To: T10 Technical Committee
 From: Heng Liao, PMC-Sierra (liaoheng@pmc-sierra.com),
 Steve Gorshe, PMC-Sierra (steve_gorshe@pmc-sierra.com),
[Tim Symons, PMC-Sierra \(Tim_Symons@pmc-sierra.com\)](mailto:Tim_Symons@pmc-sierra.com) and
 Tom Grieff, HP (thomas.grieff@hp.com)
 Date: ~~June 13~~ July 6, 2005-2005
 Subject: T10/05-144r43 SAS-2 zoning

Suggested Changes

Figure 44 — Expander zone route table example

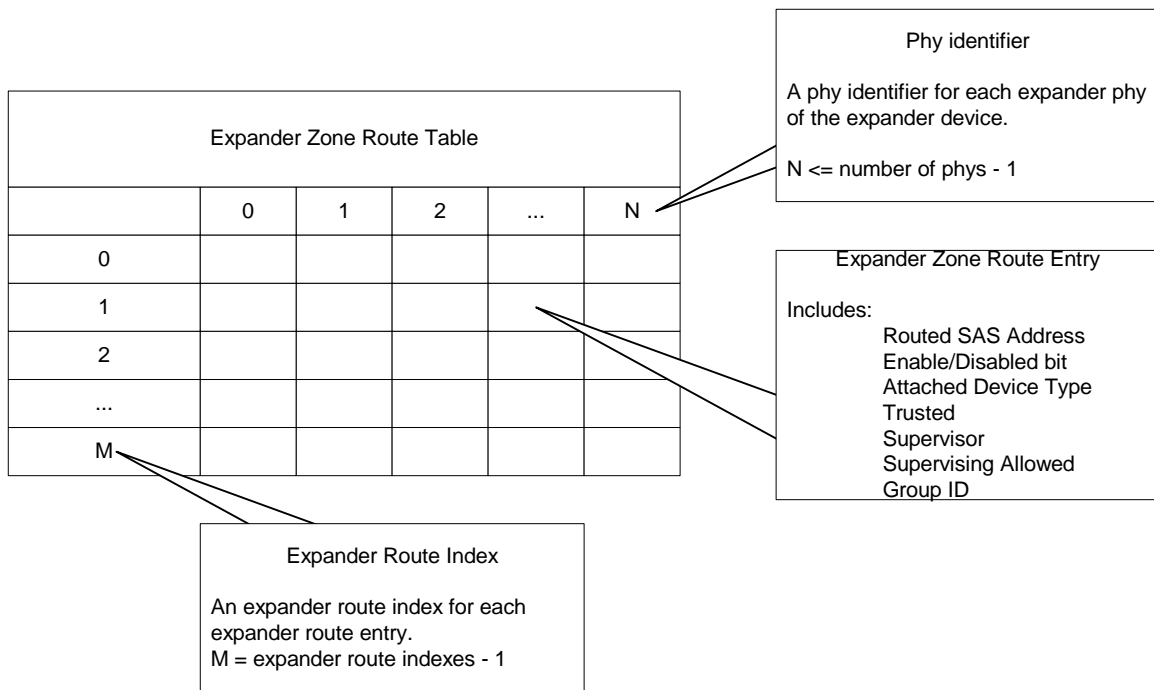
A zoning expander device that supports the table routing method shall contain an expander zone route table. The expander zone route table is a structure that provides an association between routed SAS addresses to expander phyPhy identifiers, the PHY ZONE configuration attributed such as TRUSTED, SUPERVISOR, GROUP ID, Supervising-AllowedSUPERVISING PRIORITY, attached device type. Each association represents-is represented by an-one expander route entry.

Figure 44 shows a representation of an expander route table.
